HOSHIZAKI AMERICA, INC.

SERVICE BULLETIN

SB09-0007

Subject: WIRING CHANGE TO THE F-1500M_H

Original Wiring

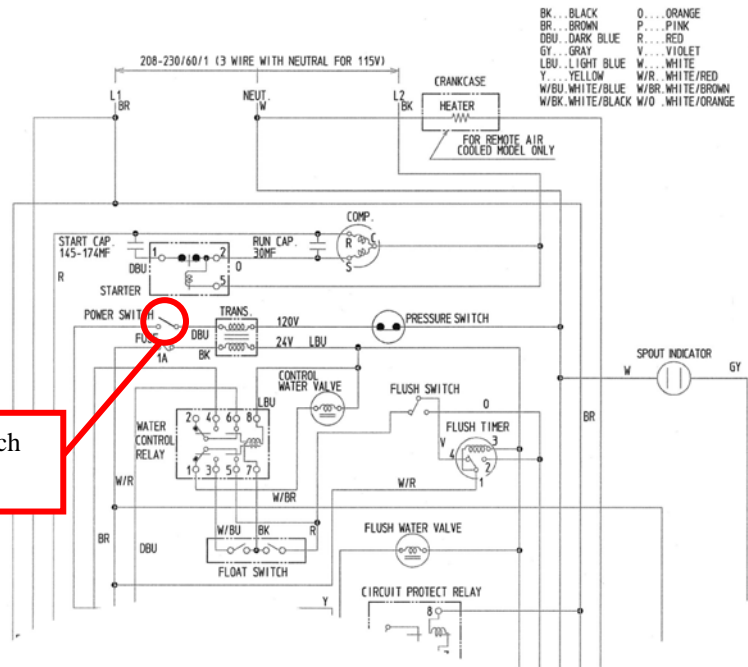
Starting in April 2009 Hoshizaki has changed the wiring location of the main control switch. The control switch was originally wired through the main power supply wires coming in the control box. The new location is on the dark blue wire going to the primary side of the control transformer. See wiring diagrams below. This change allows for standardized wiring across the flaker line.

New Wiring
